City of Sugar Creek

Addendum No. 1

RE: Lewis and Clark Expressway – Sterling Ave. Project
Sugar Creek, Jackson County
Federal Aid No.: DP-3400(408)

DATE 11-08-12
SHEET NO. 4

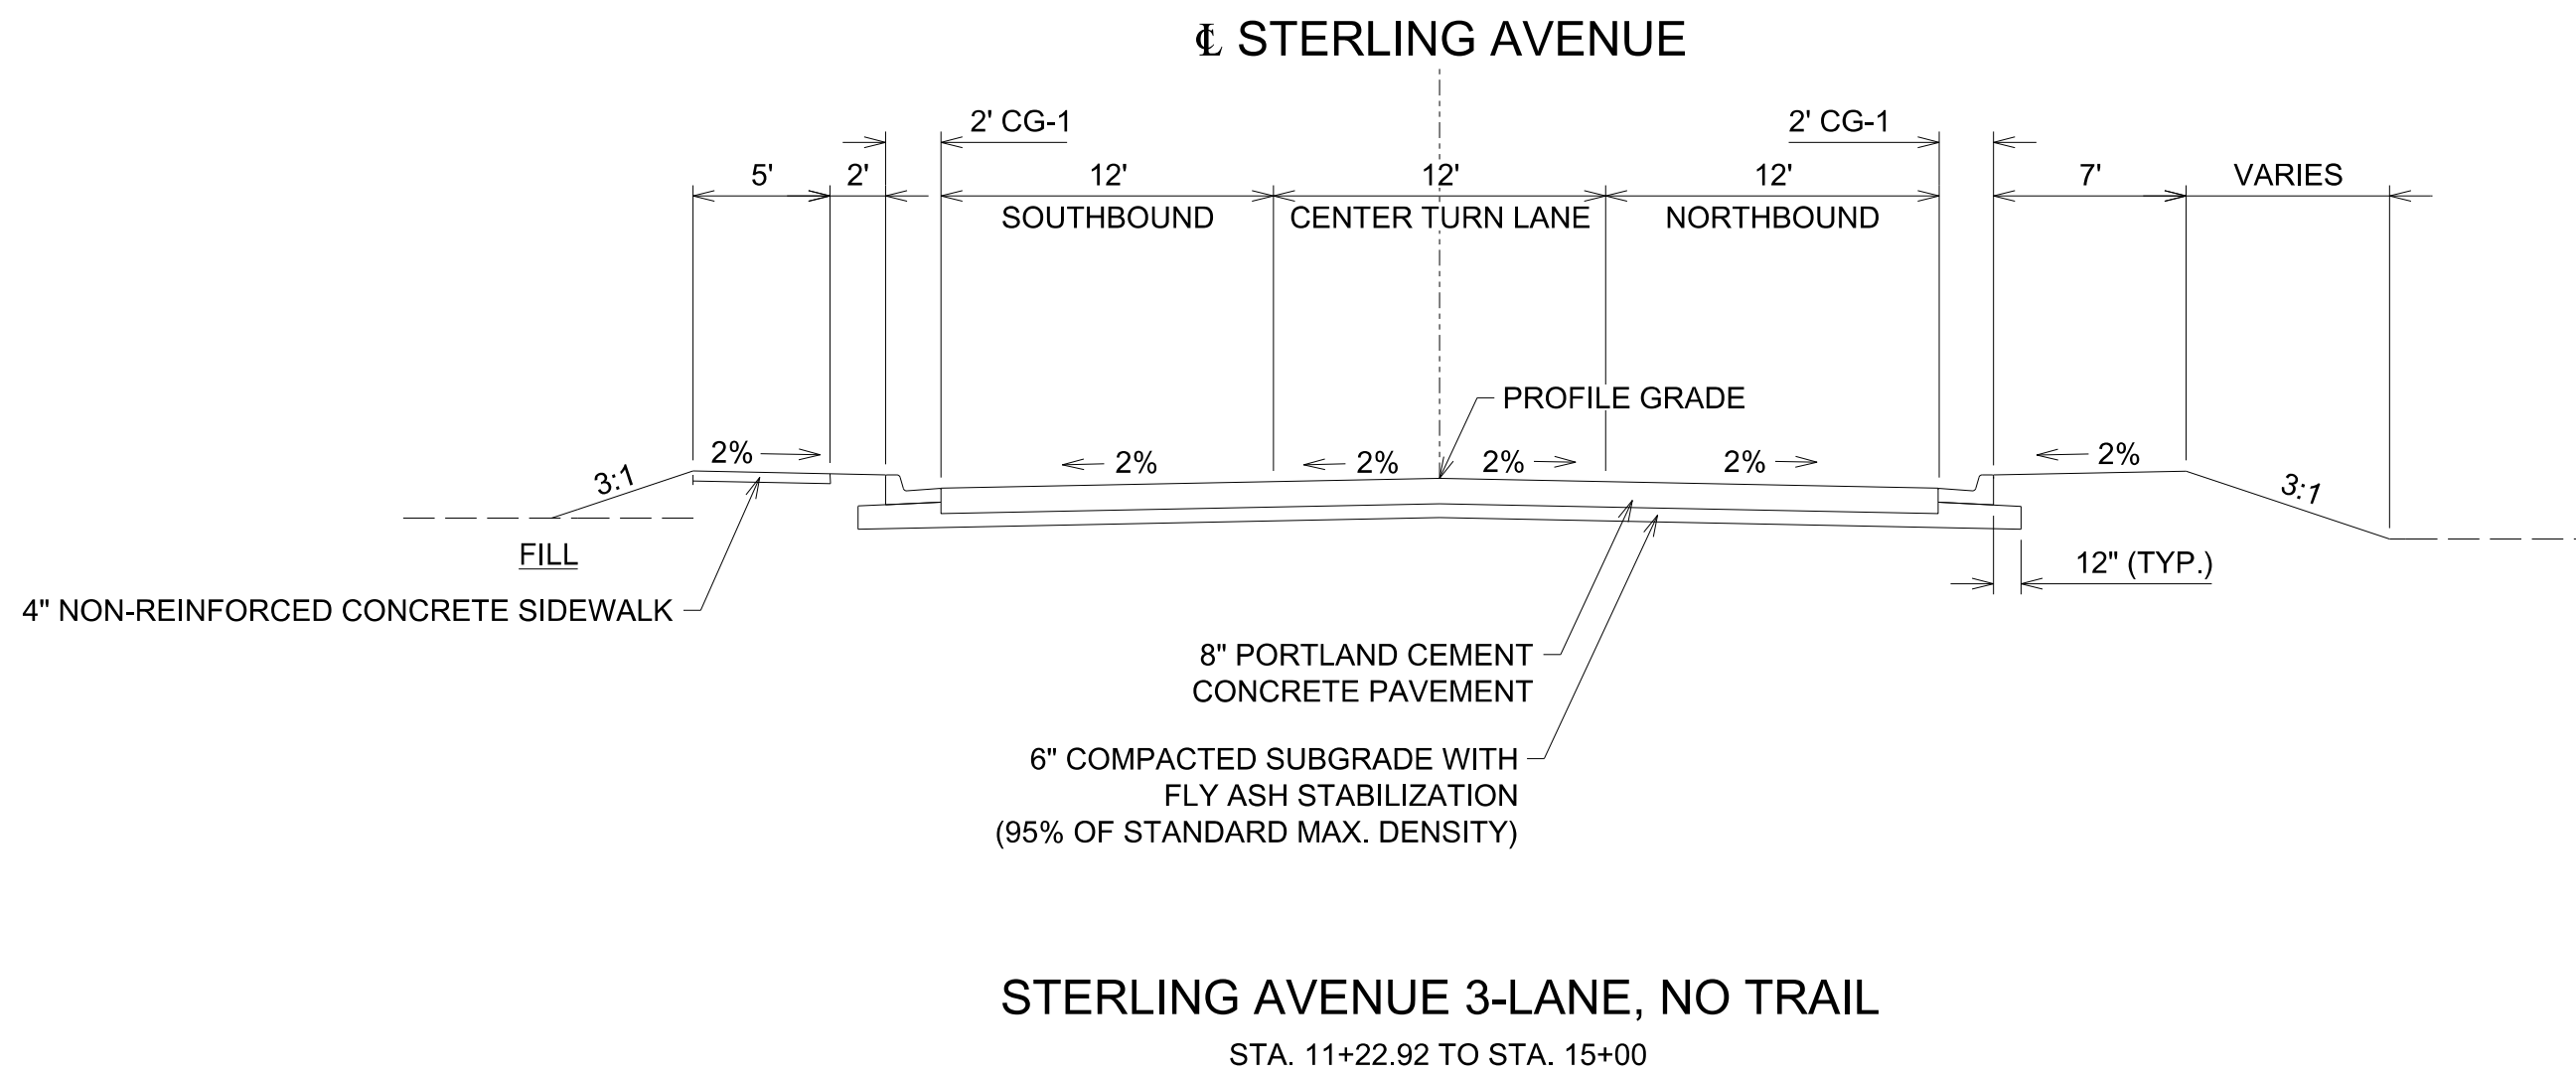
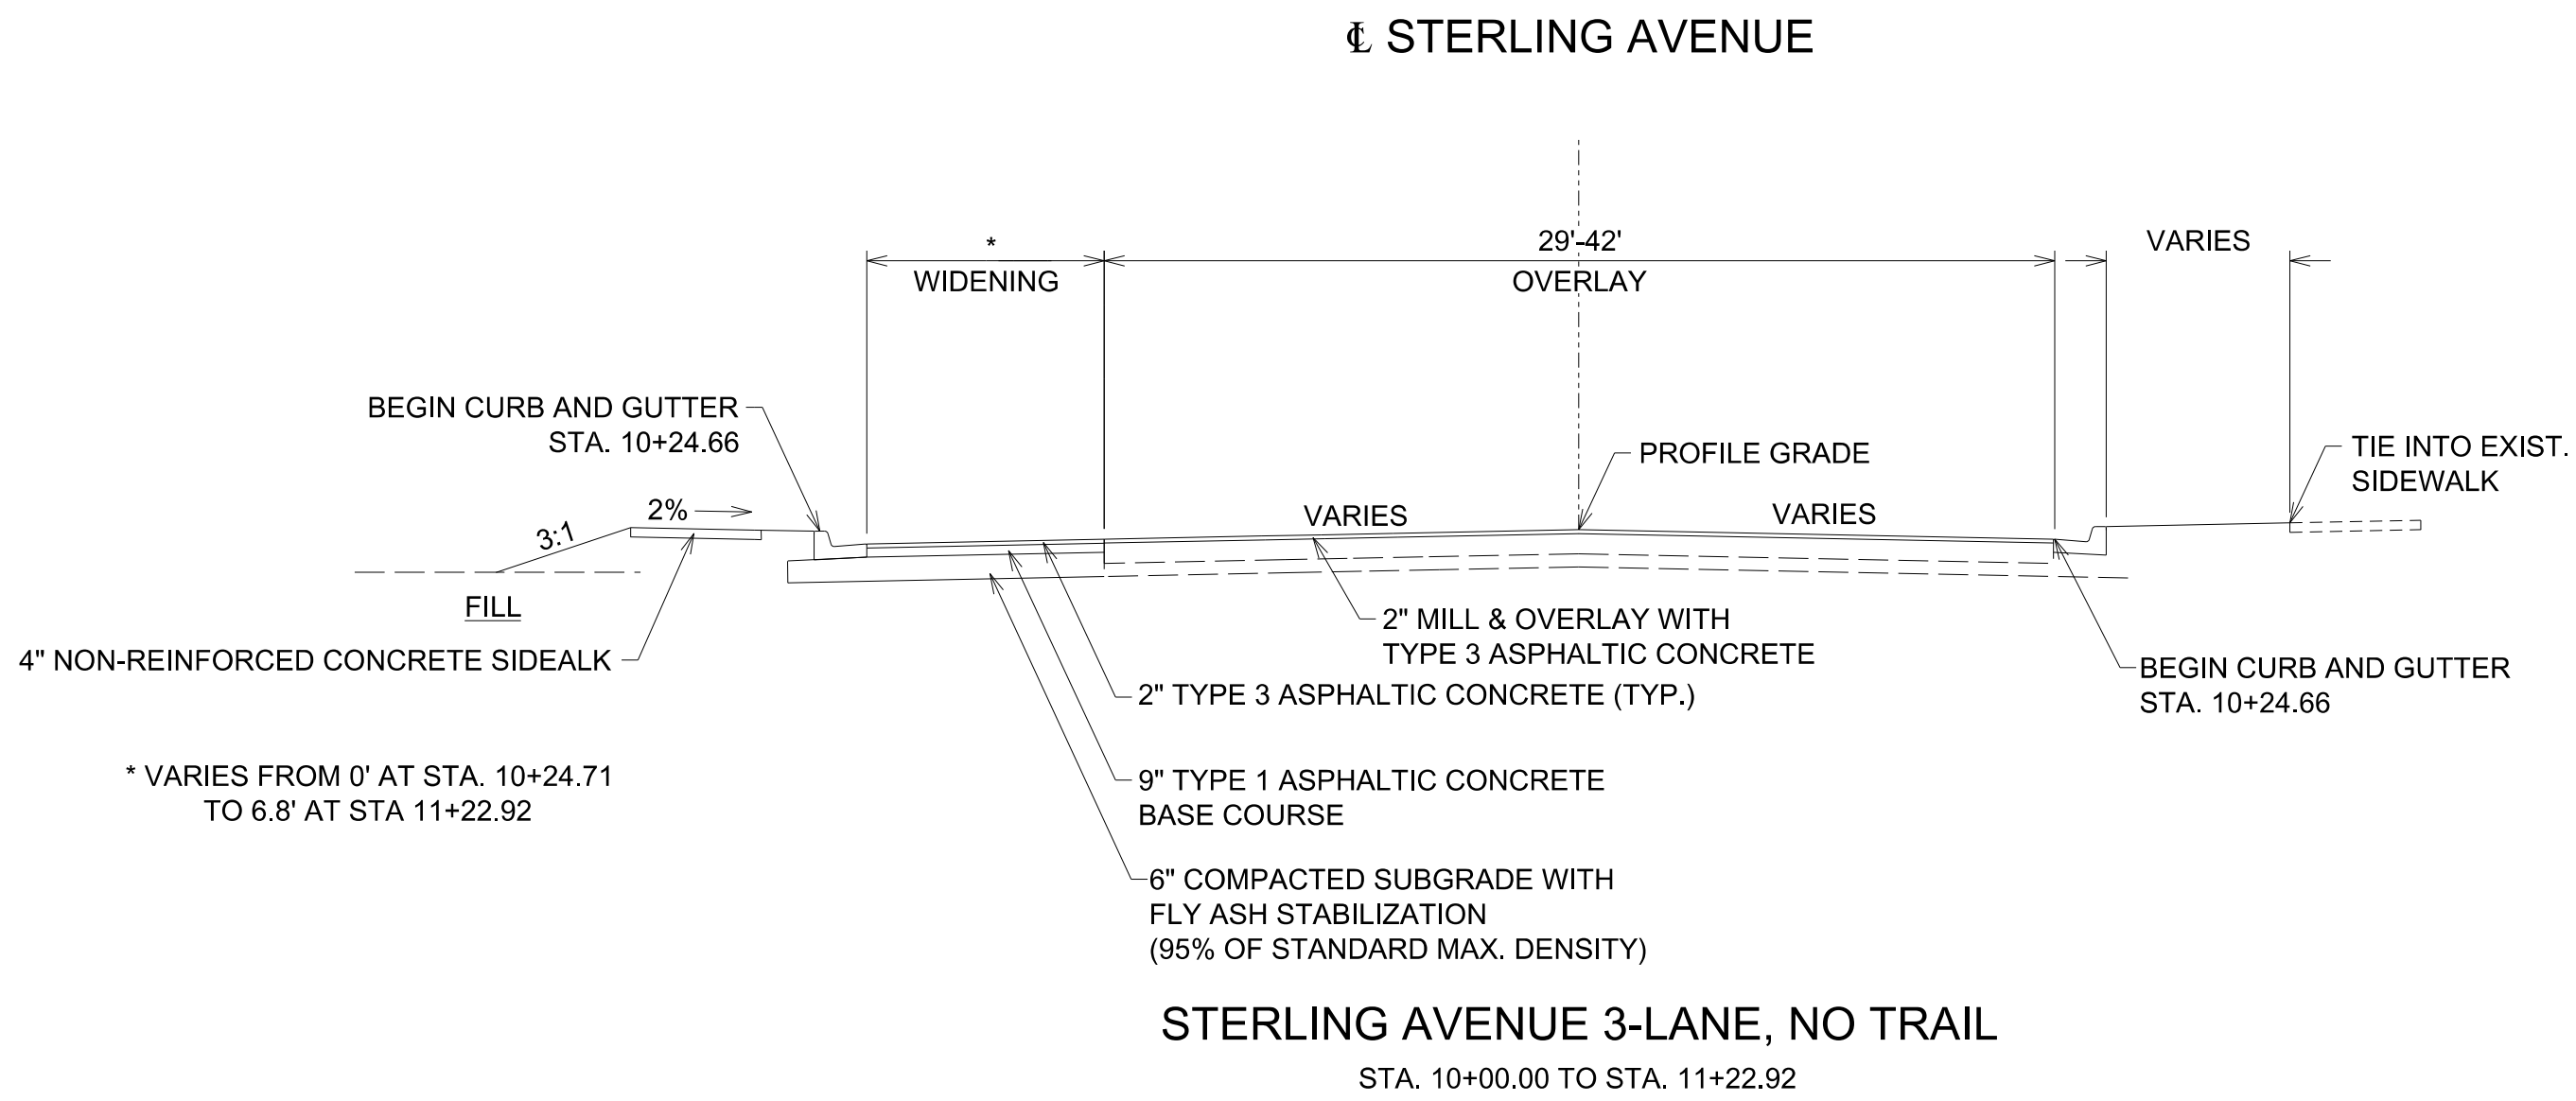
- a. Typical Section Sheet 1 (Plan Set Sheet No. 4) – The bottom typical section incorrectly showed grading leading to a new curb and gutter line from Station 12+75 to Station 14+75. This has been removed from the plans. Quantities for these improvements were not included within the bid sheet or quantity sheets; therefore there is no change in quantities. The revised typical section sheet is attached as 004_001_LCE_Sterling_TypSec.PDF.

DATE	DESCRIPTION
11/08/12	REMOVED CALLOUT FROM 12+75 TO 14+75, STERLING AVENUE, RT. SIDE
